## **VARIOUS SCHOOL SITE ROOF REPAIRS**

### **ITB# 023-077-05**

#### **Addendum No. 2**

LOVE  
ELEMENTARY  
SITE PLAN

Sheet: A-0.1

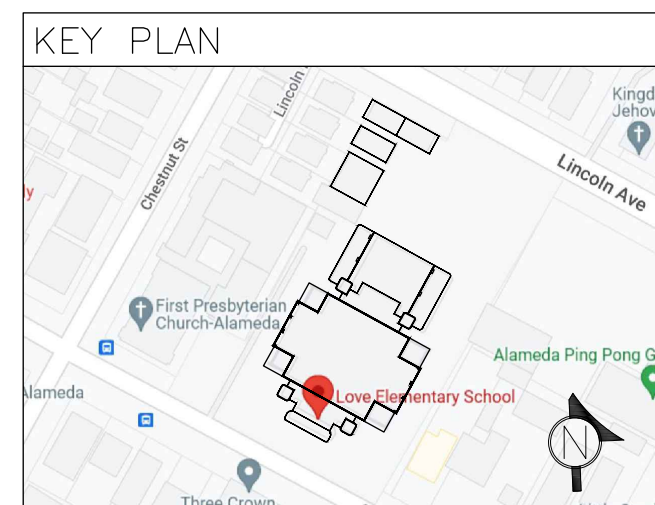
Item #1: Page 3, DWG: A-0.1 Love Elementary Site Plan; removed section of lower roof at front of school that was replaced 2017. (See revised drawing enclosed)

Item #2: Page 3, DWG: A-0.1 Love Elementary Site Plan; Added "Install Polyiso Taper providing 1/4-inch slope throughout roof section" for all lower roof sections, as shown on the revised drawing. (See revised drawing enclosed)

Item #3: Page 3, DWG: A-0.1 Love Elementary Site Plan; Added "Install raised edge detail for lower roof sections adjacent to Multi-Purpose Roof, as shown on the revised drawing. (See enclosed Installation Detail)

Addendum No. 2;  
Install Polyiso taper providing 1/4-inch slope throughout roof section

Addendum No. 2;  
Install Raised Edge Detail (see attached detail provided)

Addendum No. 2;  
Install Polyiso taper providing 1/4-inch slope throughout roof section

Addendum No. 2;  
Install Polyiso taper providing 1/4-inch slope throughout roof section

Addendum No. 2;  
Install Raised Edge Detail (see attached detail provided)

Addendum No. 2;  
Install Polyiso taper providing 1/4-inch slope throughout roof section

Addendum No. 2;  
Lower roof to be removed from Scope
